ALERT SERVICE BULLETIN

NO. 206L-09-163

MODEL AFFECTED: 206L Series

SUBJECT: MAIN ROTOR BLADES P/N 206-015-001-115, /-117, /-119 & /-121 SPAR SPACER, ONE TIME INSPECTION OF.

Figure 2. Main Rotor Blade Area to be checked.

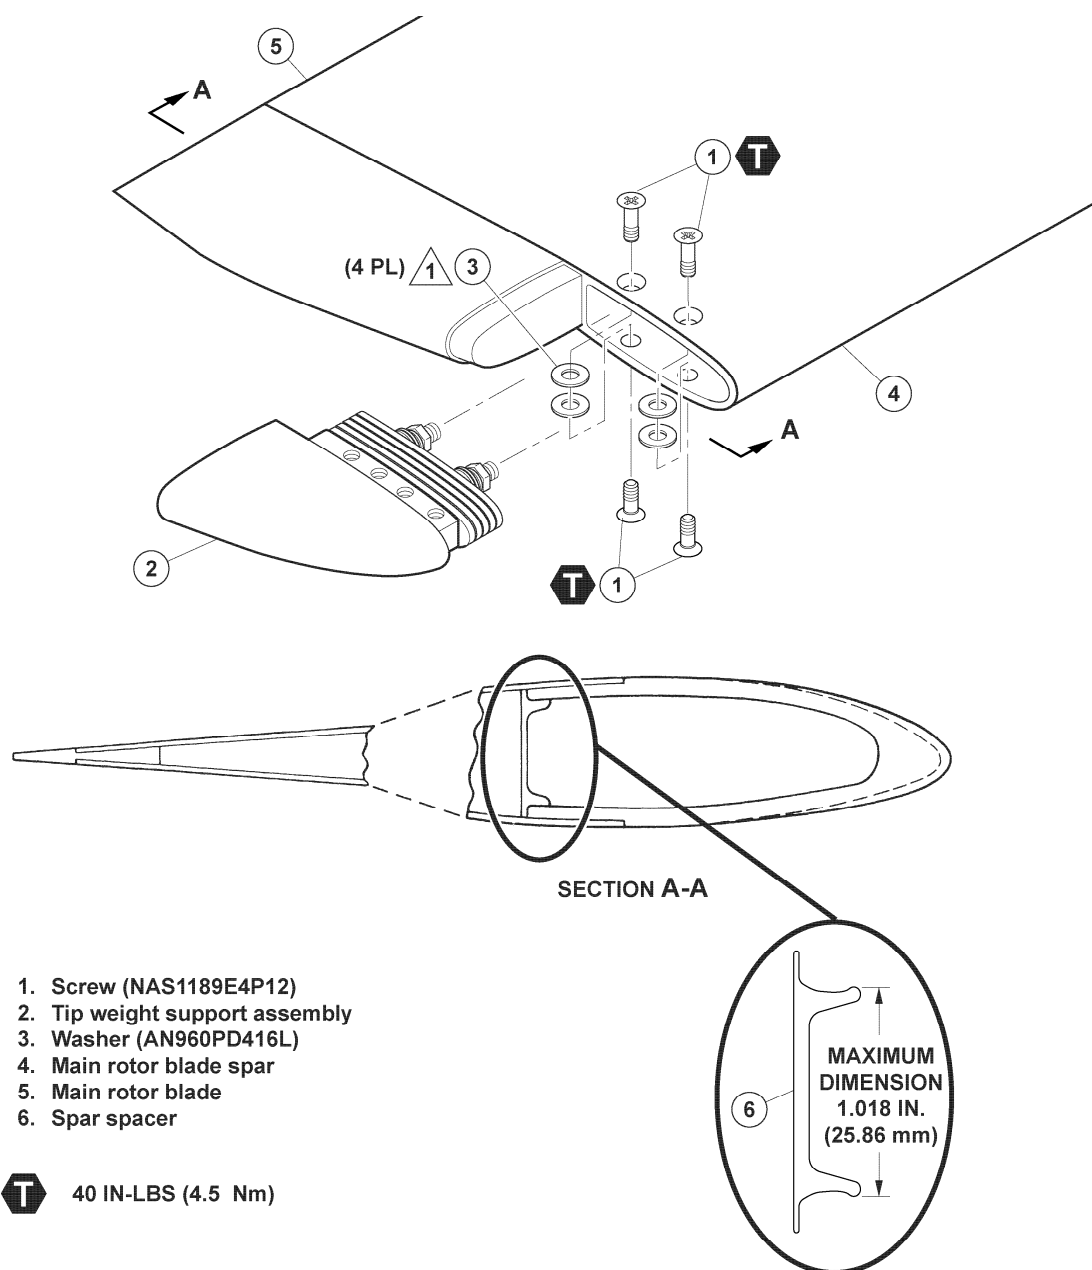
3. Mark the top surface of affected main rotor blade to identify station 100 and 145 as follows:
 - a. The center of the blade bolt is blade station 18.5 (blade station zero being at the center of the mast). Use a permanent ink marker and make marks at blade stations 100 and 145. Refer to Figure 2.

- c. Blade stations can be located by placing a measuring tape at the center of the blade bolt hole. The center of the blade bolt is blade station 18.5 (blade station zero being at the center of the mast). The blade should have marks at stations 100 and 145 previously made in Part III. (Refer to Figure 2).

Shown area STA 100.0 - 145.0 is applicable to Part II recurring wipe check of this bulletin. Blade STA 90.0 - 145.0 (STA 90.0 not shown) is the area to x-ray per Part III b of this bulletin.

Figure 1. Main rotor blade spar spacer inspection.

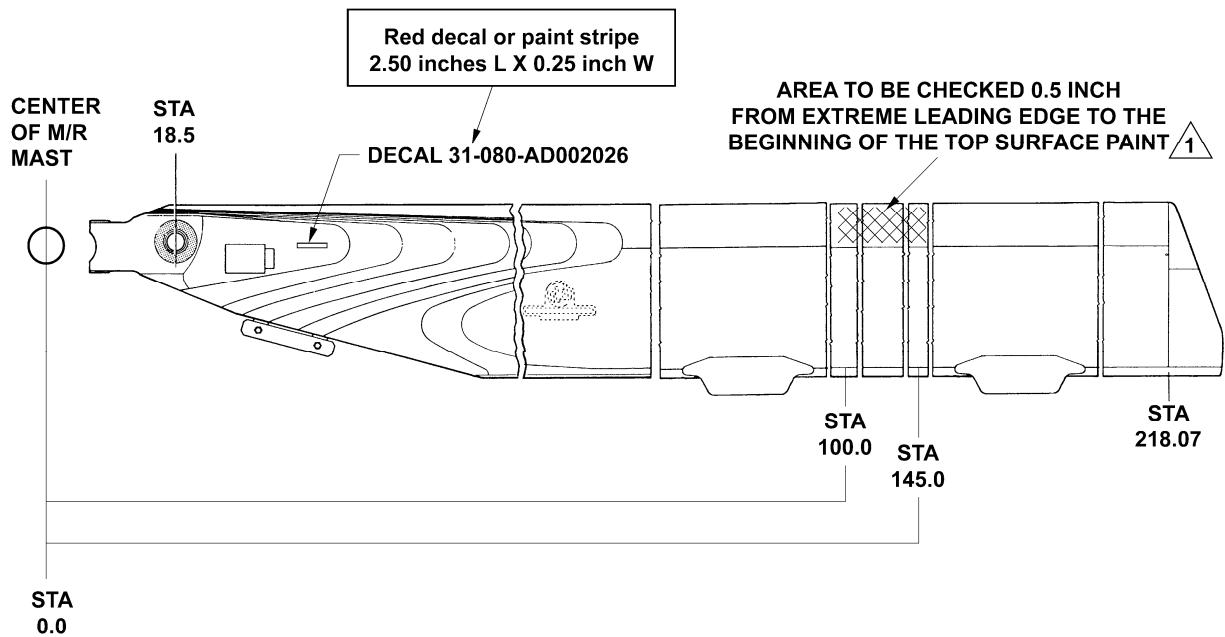
1. Remove the tip weight support assembly (2) from the main rotor blade (5) as follows: (Refer to Figure 1).
 - a. Remove the four screws (1) holding the tip weight support assembly (2).
 - b. Use a soft scraper and remove the filler around the tip weight support assembly (2).

- b. Use a caliper and measure the main rotor blade spar spacer (6) width as shown on Figure 1.
 - c. Record your dimension.
- 3. Proceed with the installation of the tip weight support assembly (2) on the main rotor blade (5) as follows:

4. For main rotor blade (5) with spar spacer (6) that are **“WITHIN”** spar spacer width. This maximum dimension shall not exceed 1.018 inch (25.86 mm), proceed as follows:
 - a. Make required helicopter record entry indicating the finding and that PART II B) of this Alert Service Bulletin is accomplished. No further action is required.
5. For blades with main rotor blade spar spacer (6) that are **“LARGER”** than the maximum dimension of 1.018 inch (25.86 mm), proceed as follows:
 - a. Use a vibrating tool and strike through the last three digits of the main rotor blade Part Number on the data plate. Re-identify main rotor blade data plate in accordance with the information provided in Table 4. The dept of the vibroetch must not exceed 0.005 inch (0.127 mm).

Figure 3. Radiograph with Blades Installed.

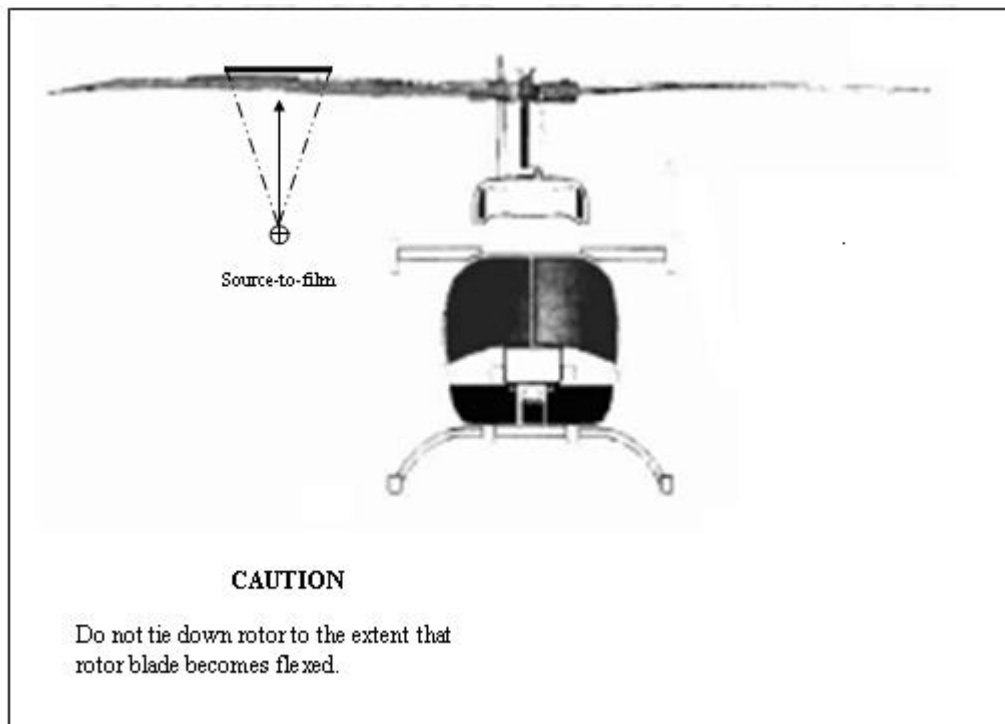
2. Blade installed on helicopter.
 - a. Rotate the blades perpendicular to the tailboom. (Refer to Figure 3).

- b. Stabilize the main rotor blades to prevent movement and film distortion.
- c. Due to the static droop and pitch angle of the blades, care must be taken to ensure the center of the X-Ray beam stays perpendicular to the bond line, (Refer to Figure 3).
- d. Inspect affected blade per above step 1. b. to 1. f..

Figure 4. Cross Section of Main Rotor Blade.

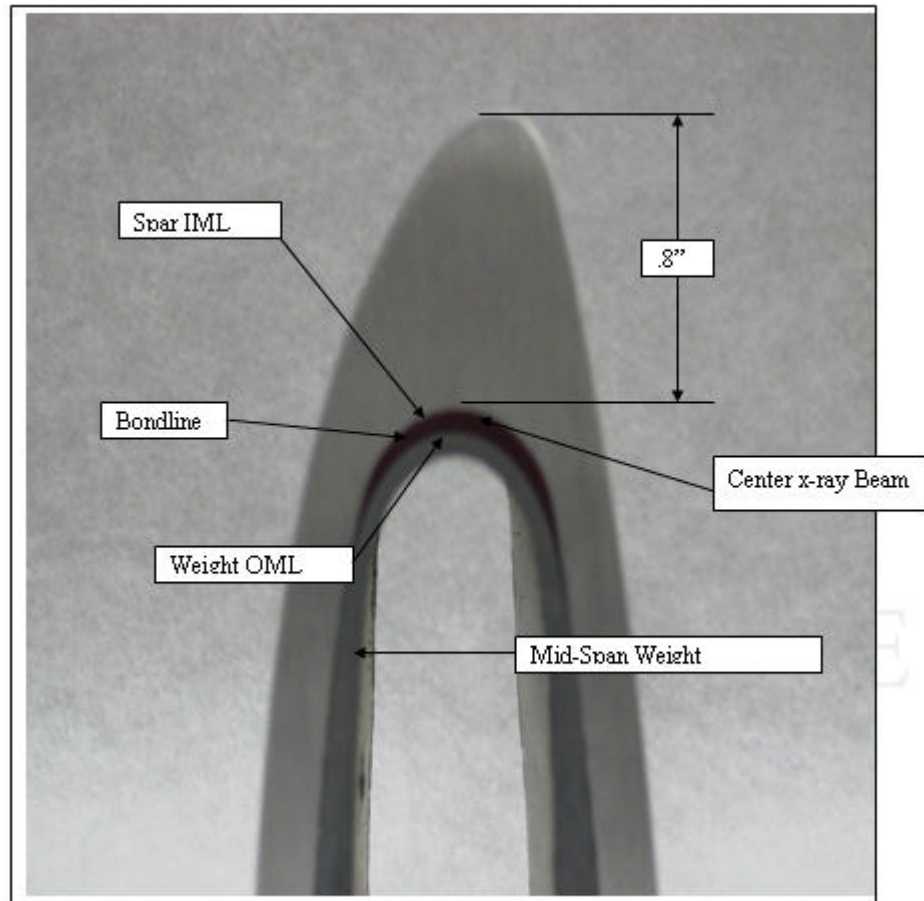
- b. The blade shall be X-Rayed at the bondline in the radius of the mid-span weight, (refer to Figures 3 and 4, from station 90 to station 145, (Refer to Figure 2).

- e. Align the X-Ray beam perpendicular to the blade lower surface and center the beam 0.8 inch from the leading edge, (Refer to Figures 3 and 4).
 - f. Process the films and return them to Bell Helicopter for review.
